Job Sheet 180272

Part No: D3394-1

Part Name: Lug

DRAWING NO. D3394	TITLE LUG	REV. B	DART AEROSPACE LTD ENGINEERING ORDER		D.E.O. NO. D3394-B-1	SHEET NO. SHEET 1 OF 1	SCALE NTS
DRAWN AJS	CHECKED	MFG. APPR.	APPROVED	DE APPR.			
DATE 09.11.04	DATE 09.11.04	DATE 09.11.04	DATE 09.11.04	DATE 09.11.04

SHEET 4 ZONE A,1 MODIFY SECTION A-A AS SHOWN:

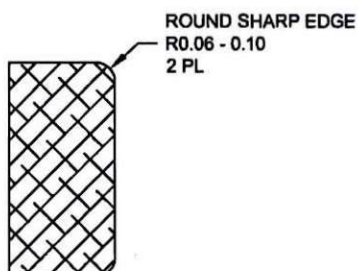
REASON: DRAFTING ERROR

D3394-1RG LUG (SHOWN)
D3394-3RG/-5RG LUGS (SIMILAR)
D3394-041RG/-043RG/-045RG LUG ASSEMBLIES (SIMILAR)

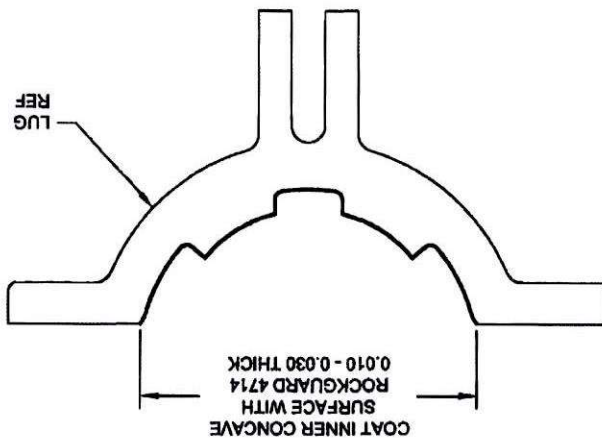
ADD D3394-XRG OPTION

D3394-XRG MOUNTING LUGS ARE IDENTICAL TO D3394-X
MOUNTING LUGS, HOWEVER AFTER FINISH, COAT INNER
CONCAVE SURFACE WITH "PLUS ONE ROCKGUARD 4714"
AS SHOWN BELOW.
